PLAN COMMISSION

A. Review of Site and Architectural Plans for the Confluence located at corner of 19th Street and East River Drive, submitted by McMahon Engineers/Architects, Kip Golden, CR Structures, and City of Two Rivers (Property Owners).

Site and Architectural Review of Confluence

Re: Confluence Lofts
DPW Plan Review / Comments

Plan Sheet 8

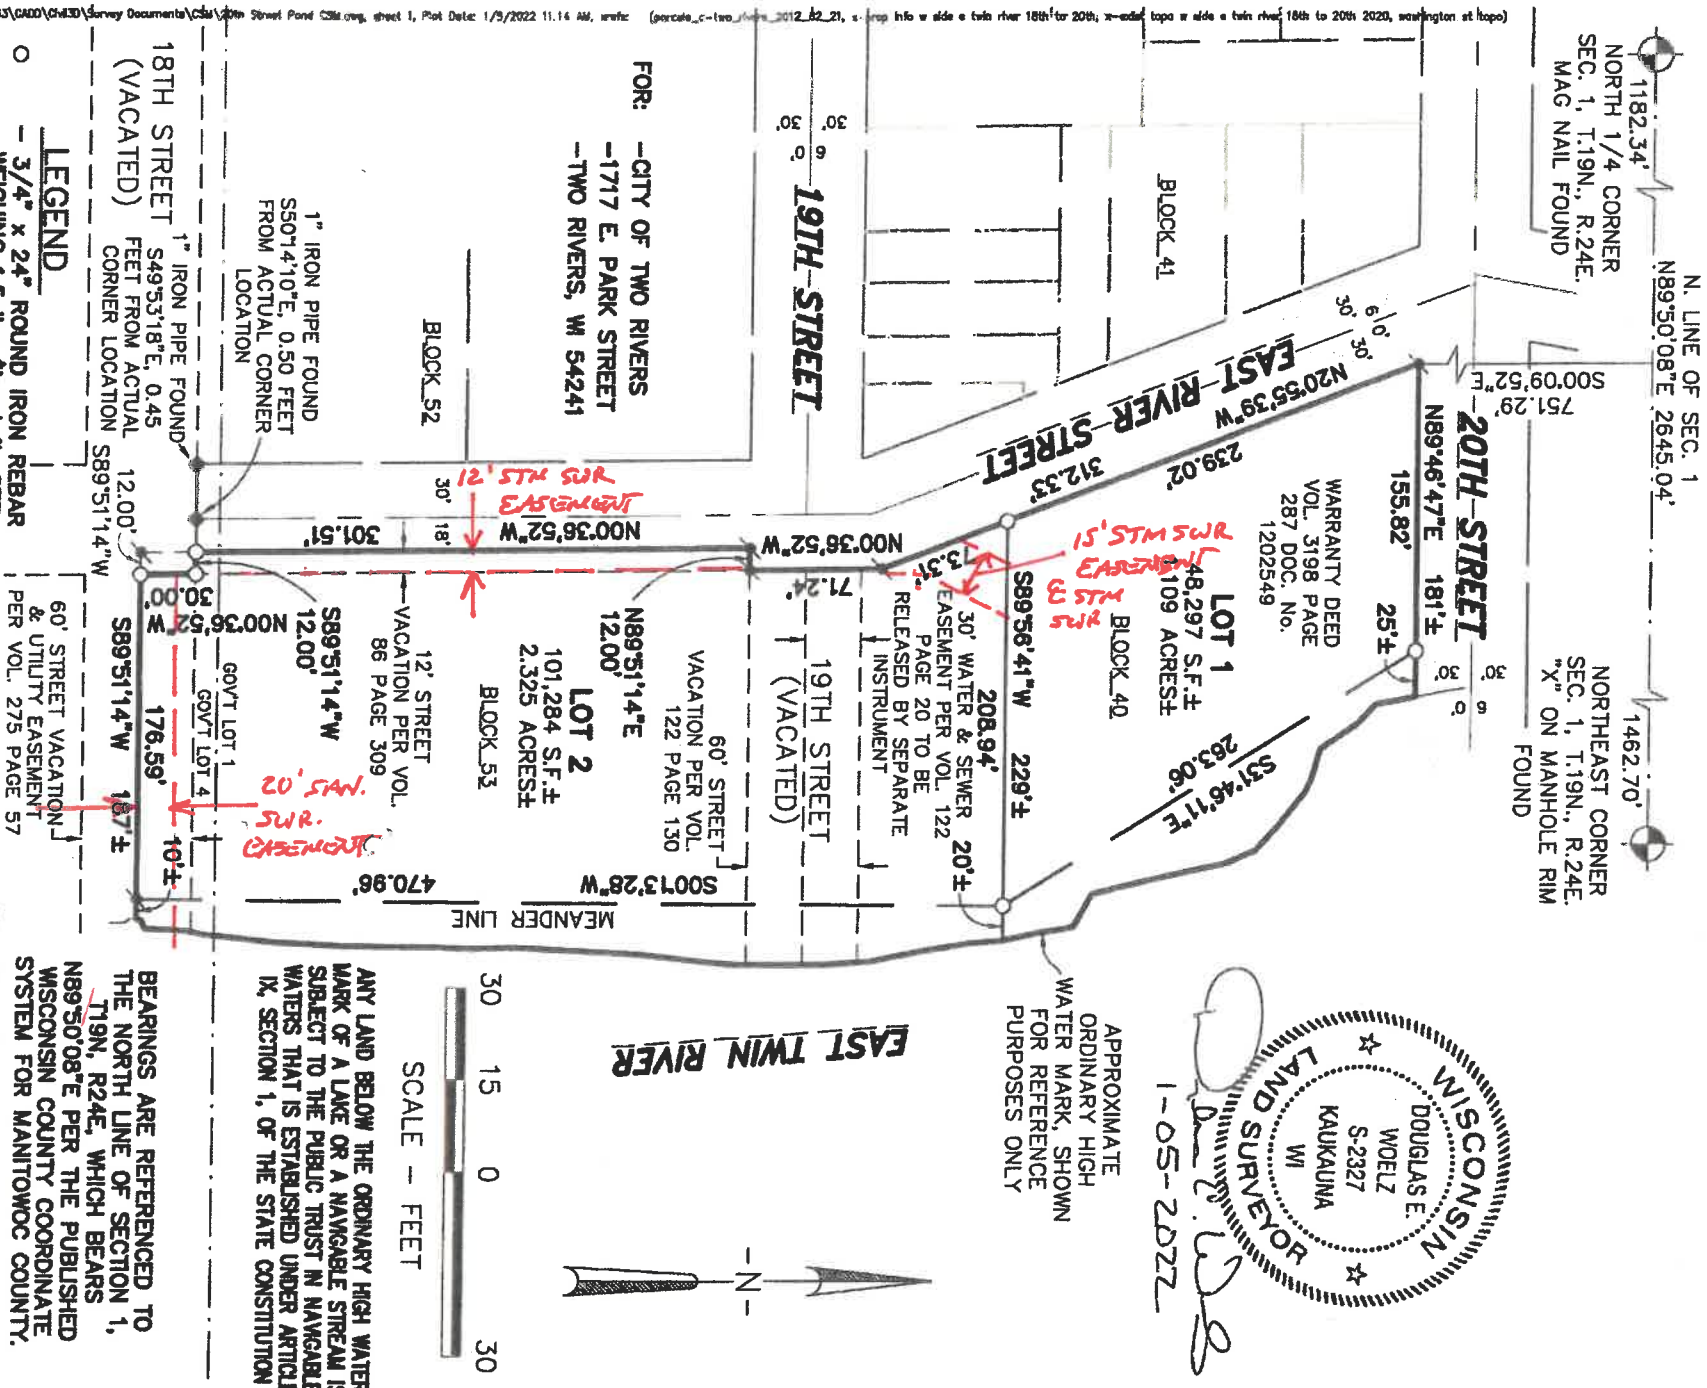
1. Is the generator / transformer pad going to be screened?
2. Are the Stella De Ora Daylilies appropriate for the narrow at grade, landscape island between the east and west parking areas south of the building especially during the winter months (plowing, sanding and salting)?

Plan Sheet 4

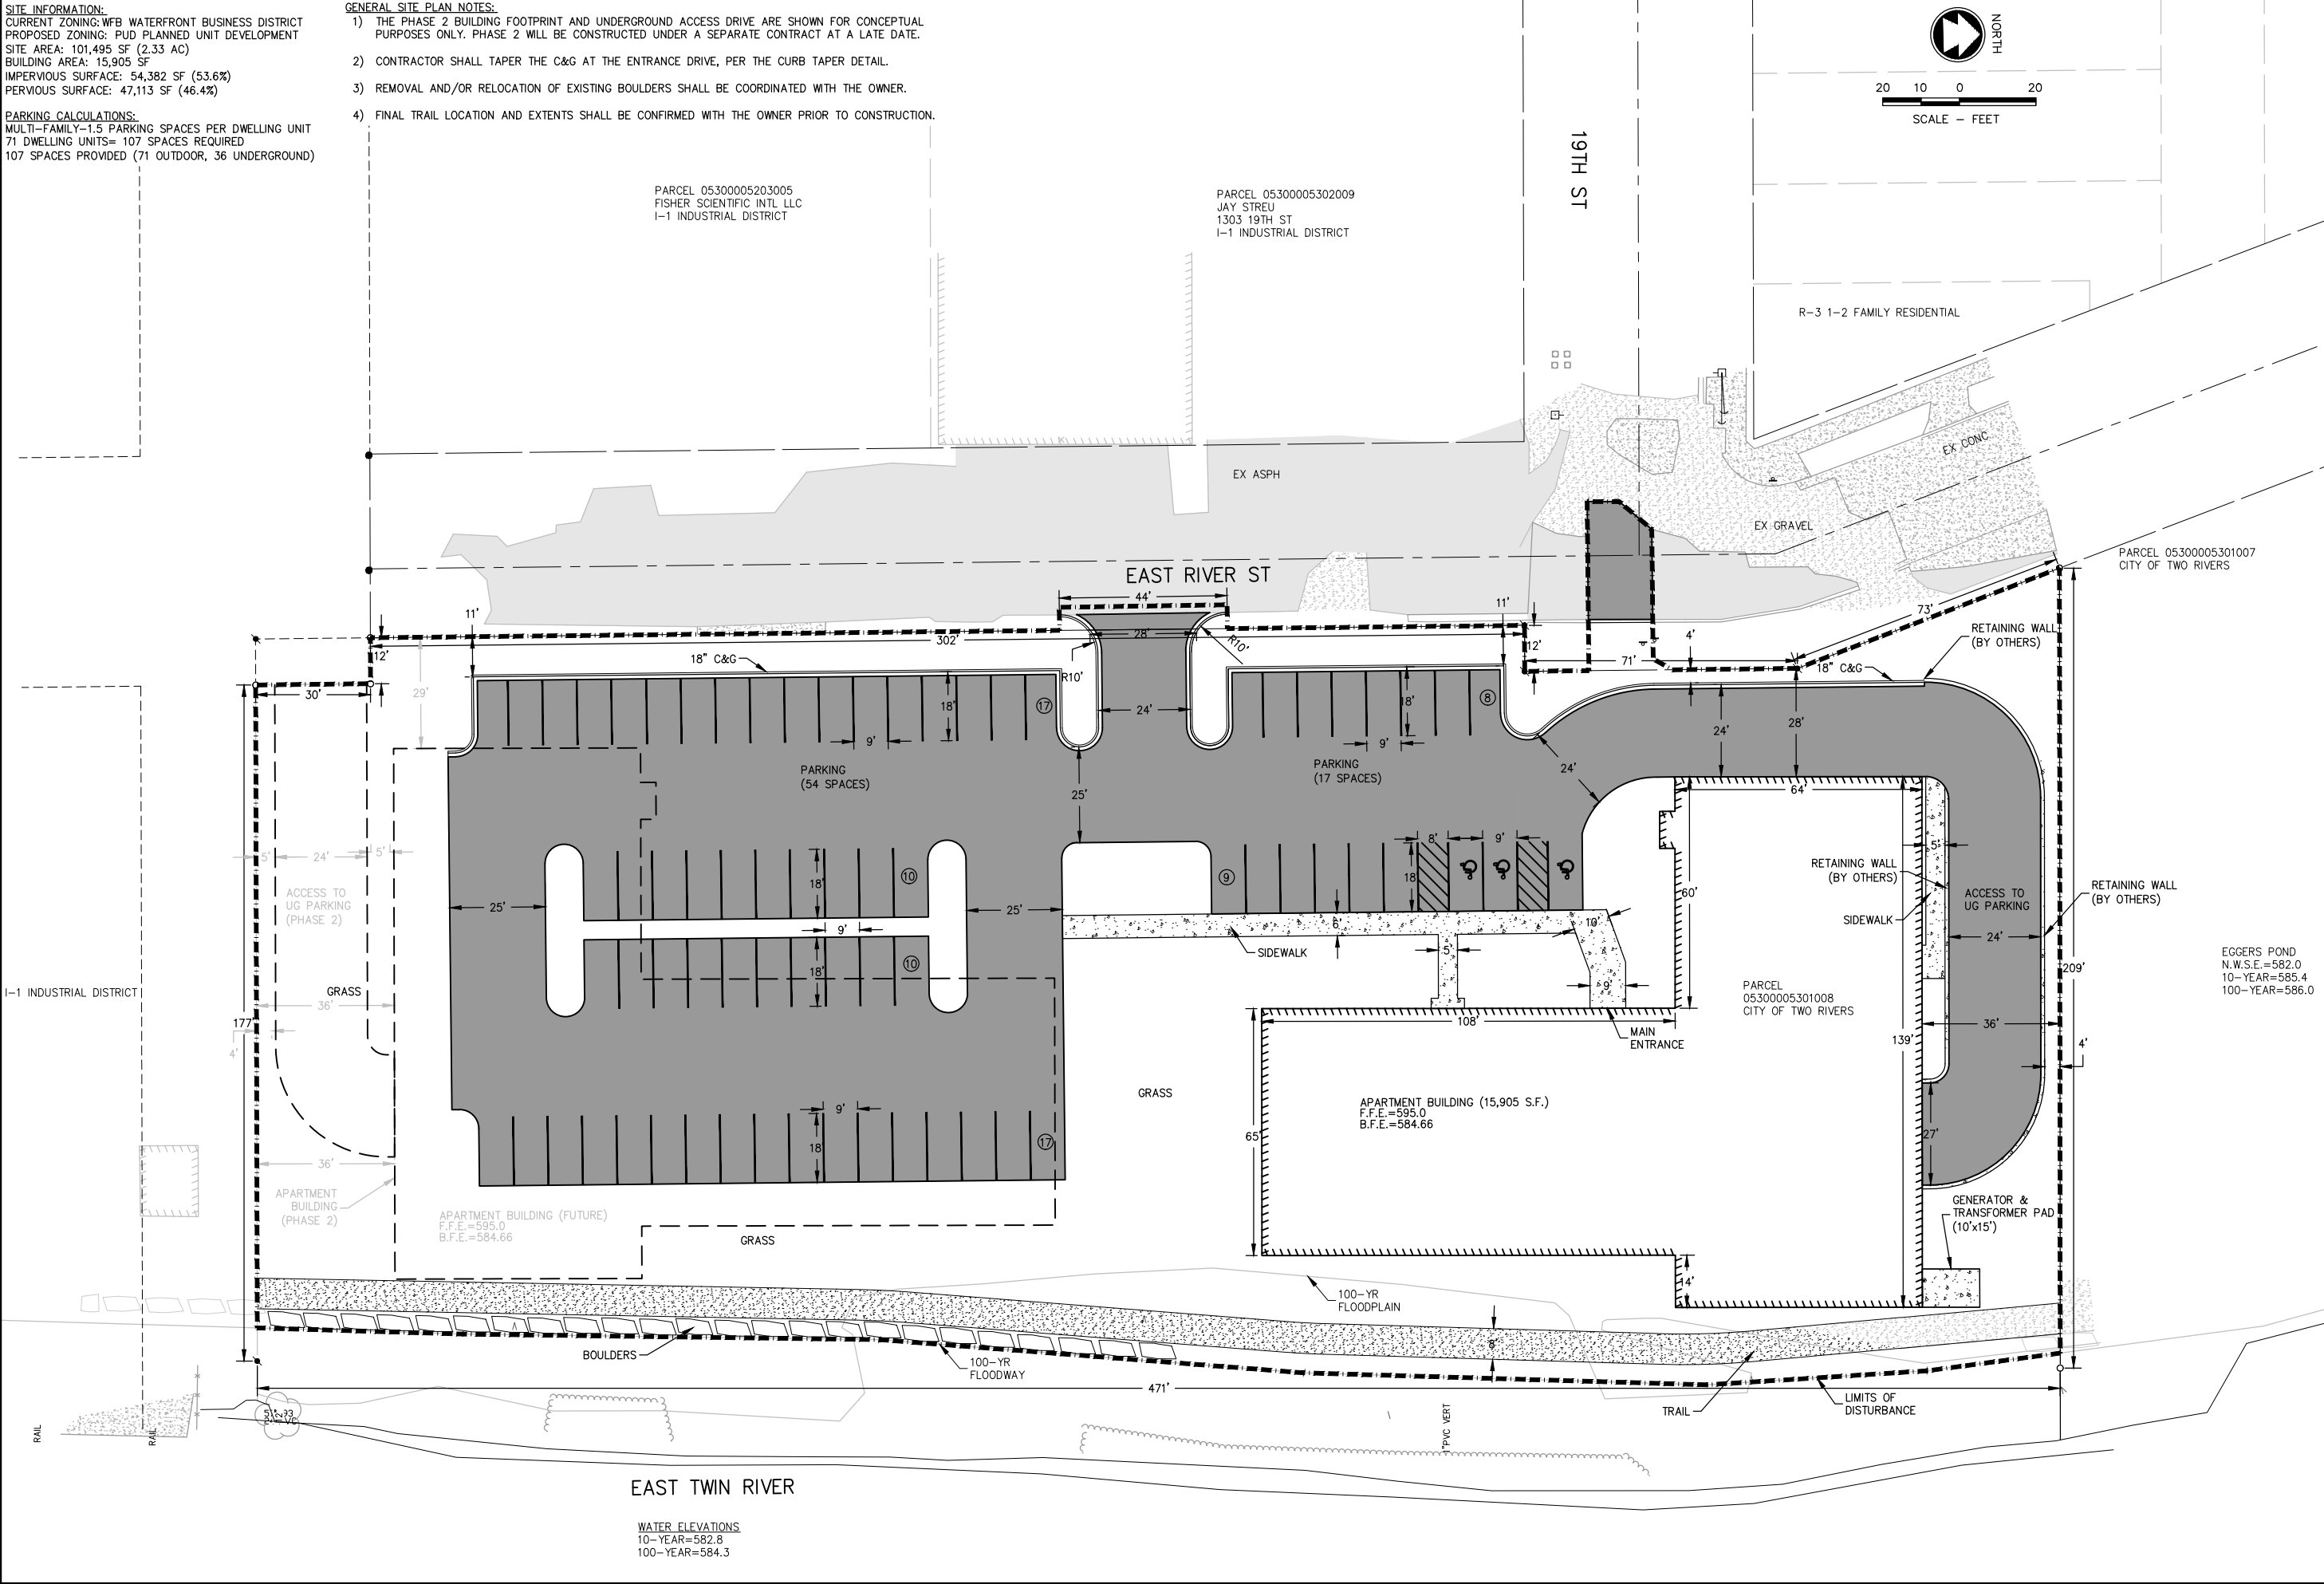
2. Eggers Pond Elevations
 - a. Normal Water Surface Elevation per Plan Sheet 4 = 582.0
 - b. 10-Year Storm Water Elevation per Plan Sheet 4 & 5 = 585.4
 - c. 100-Year Storm Water Elevation per Plan Sheet 4 & 5 = 586.0

3. East Twin River 100-Year Water Elevation per Plan Sheet 4 = 584.3
4. Proposed Basement Finished Elevation per Plan Sheet 4 & 5 = 584.66
5. Storm sewer invert elevation at STO INLET MH = 582.03 or 0.03' above normal pond elevation

Plan Sheet 7

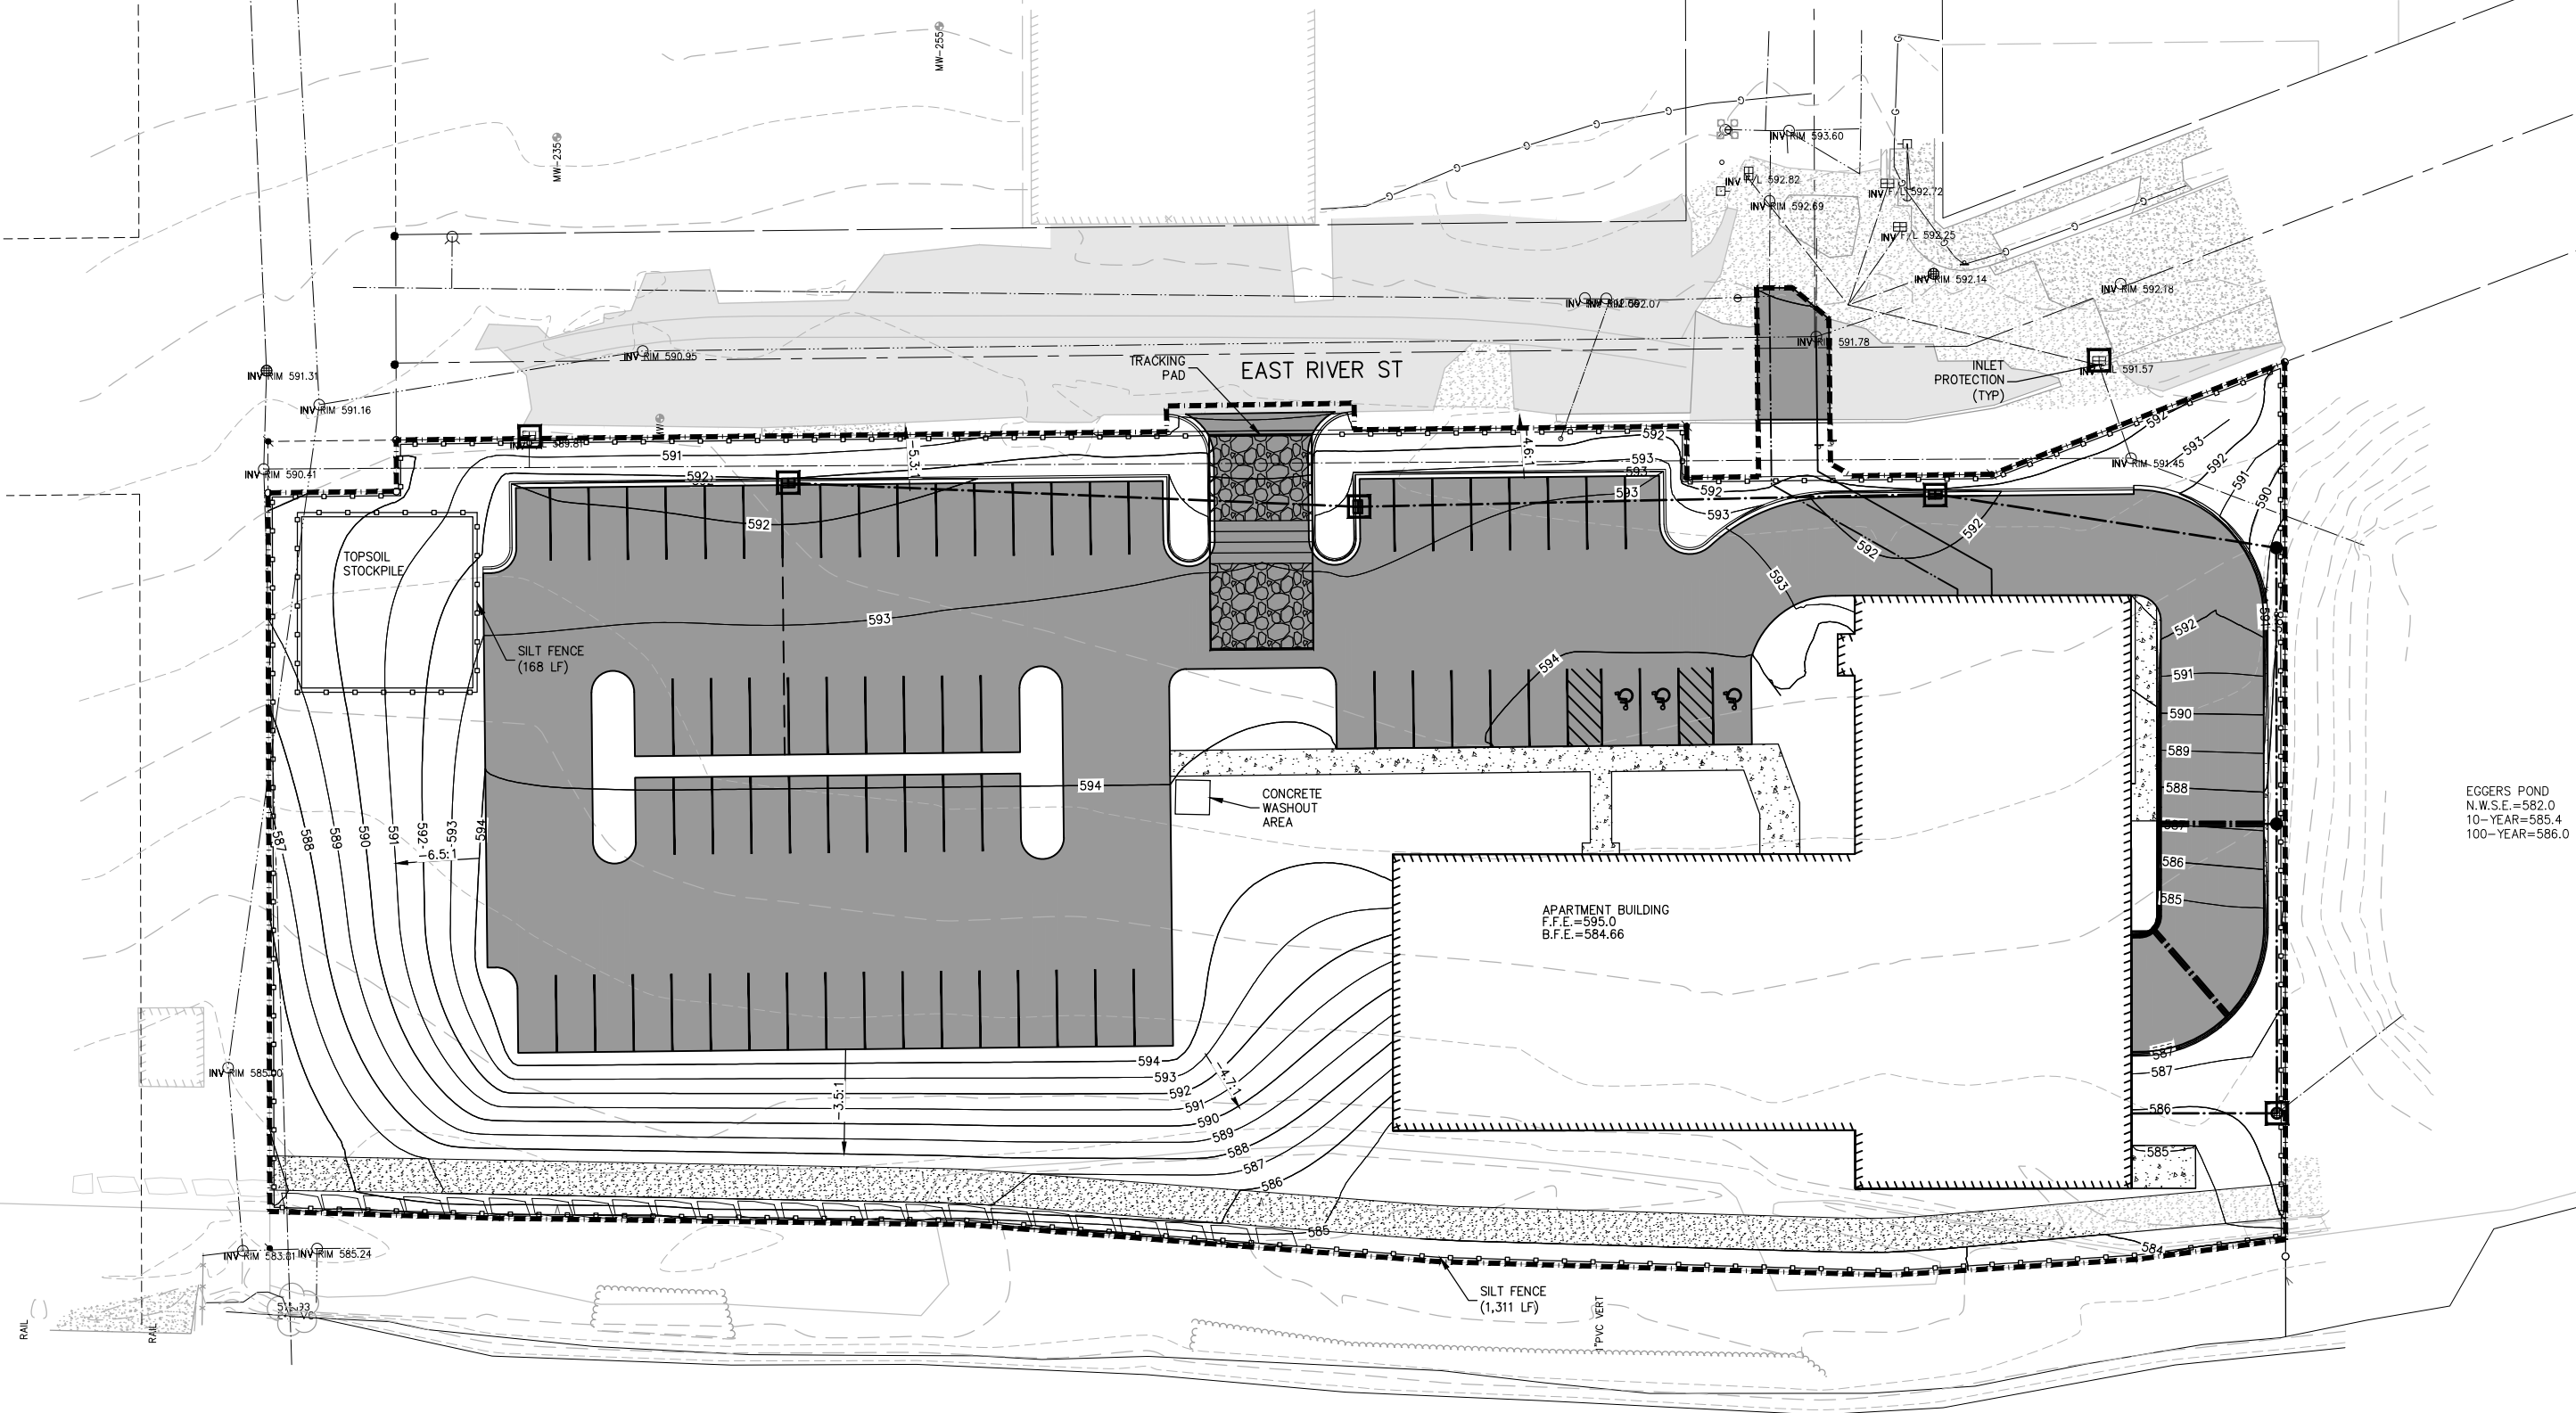
1. What type of inlet protection will be utilized for the two proposed trench drains?
2. Is a single row of silt fence going to be sufficient for the easterly and southerly slopes off the building and parking lot areas?
3. Will street sweeping be incorporated into the E.C. BMPs?
4. Provide WDNR E.C. Soil Loss Calculation worksheet.
5. See E.C. Comments above pertaining to schedule.
